Metropolitan Historic Zoning Commission
Sunnyside in Sevier Park
3000 Granny White Pike
Nashville, Tennessee 37204
Telephone: (615) 862-7970
Fax: (615) 862-7974

STAFF RECOMMENDATION
2811 Oakland Avenue
December 19, 2018

Application: New Construction—Addition and Detached Accessory Dwelling Unit
District: Belmont-Hillsboro Neighborhood Conservation Zoning Overlay
Council District: 18
Map and Parcel Number: 11704024600
Applicant: Kaitlyn Smous, Nine12 Architects
Project Lead: Melissa Baldock, melissa.baldock@nashville.gov

Figure 1. 2811 Oakland Avenue.

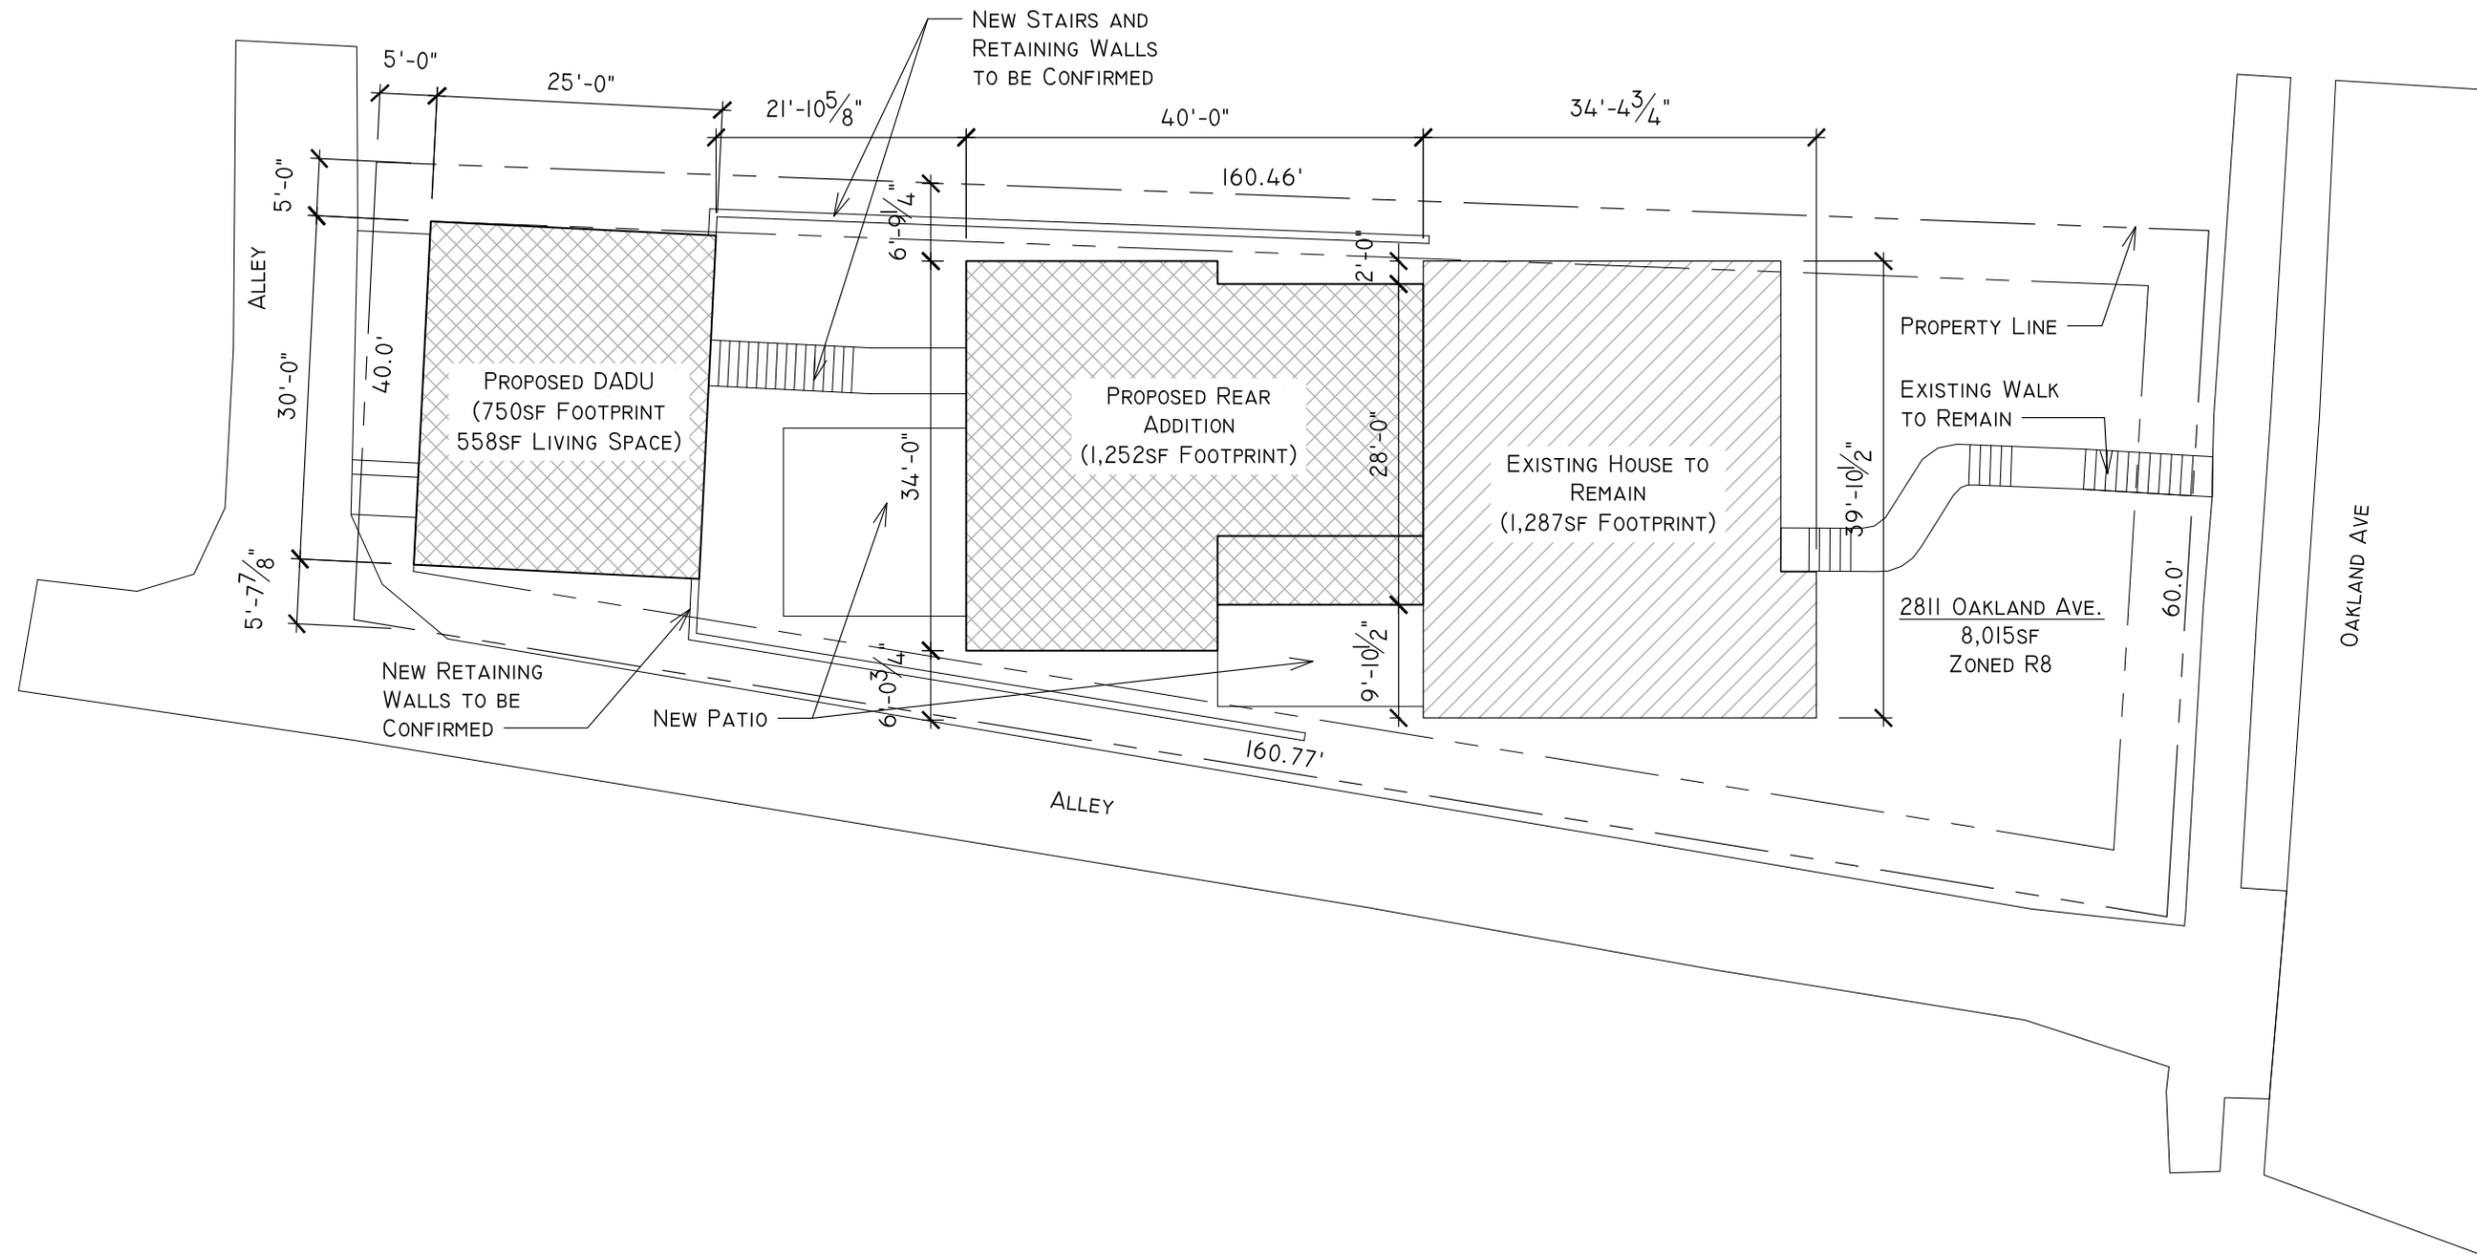
Background: 2811 Oakland Avenue is a one and one-half story brick Tudor Revival house, constructed circa 1930. The roof of the house is cross-gabled with the primary ridge running side to side and a series of smaller nested gables on the front. Because of the building's architectural character, it is considered to be contributing to the historic character of the overlay. In 2016, MHZC approved a rear addition to the house, but that addition was never constructed. This application represents a new design and a new applicant.
